National Transportation Safety Board

Bridge Design Errors

Dan Walsh, P.E.

FIGG's Demand Models

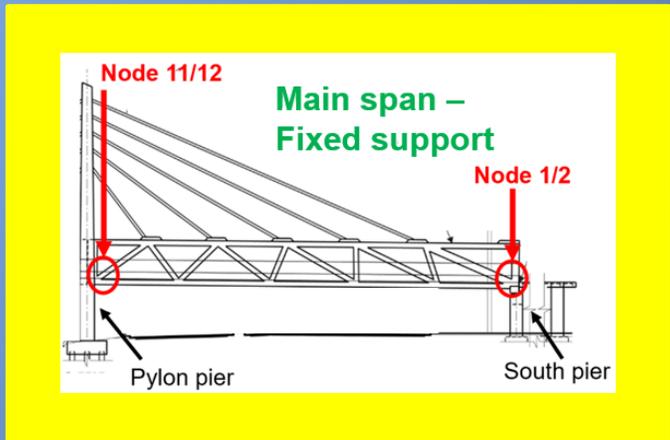
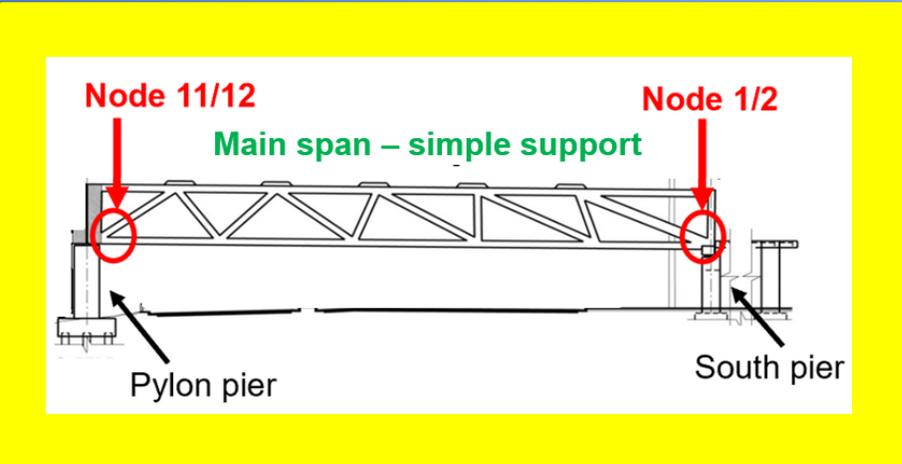
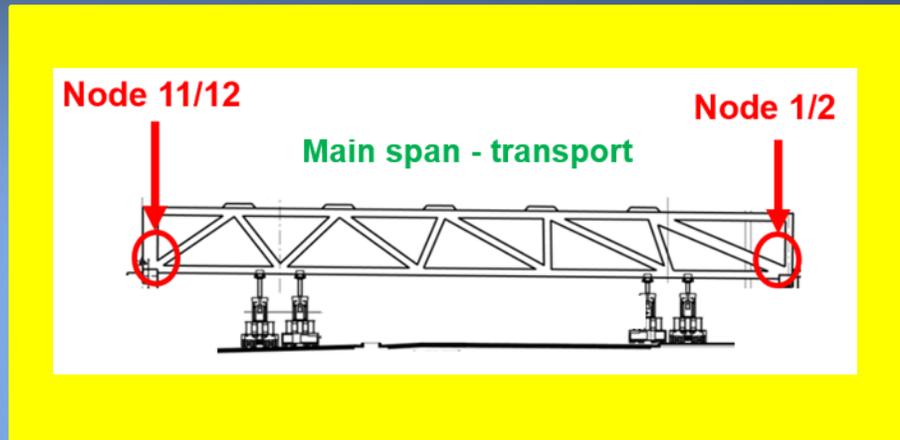
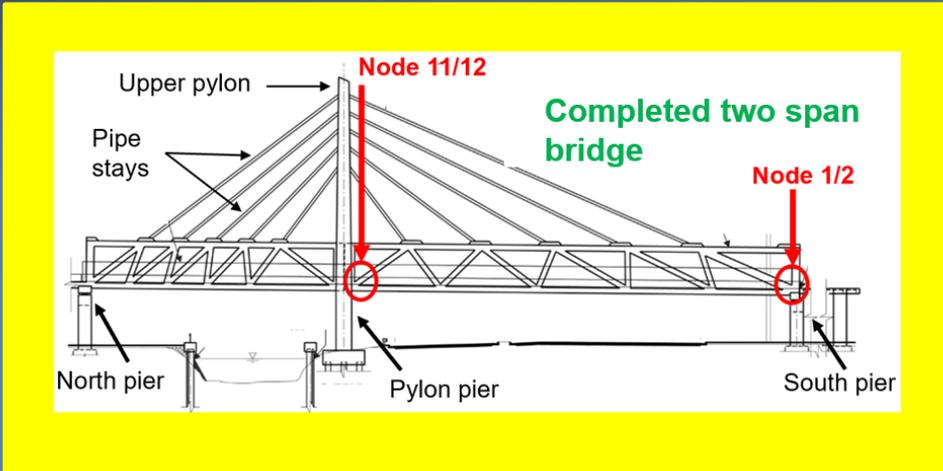
Source: FIGG, annotated by the NTSB

Demand Errors

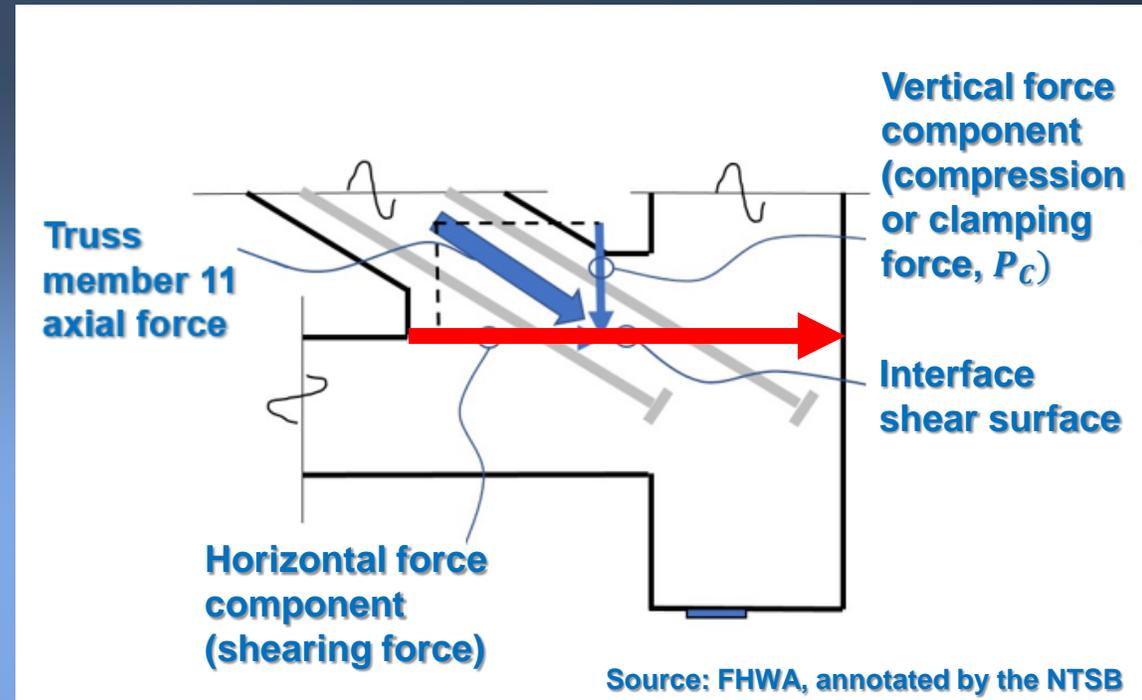
- Vertical component is compressive or clamping force
- Horizontal component is shearing force on the interface shear surface

Model	Shear Demand
FIGG's fixed support model	978 kips
FIGG's completed two-span model	1,990 kips
FHWA model	1,835 kips
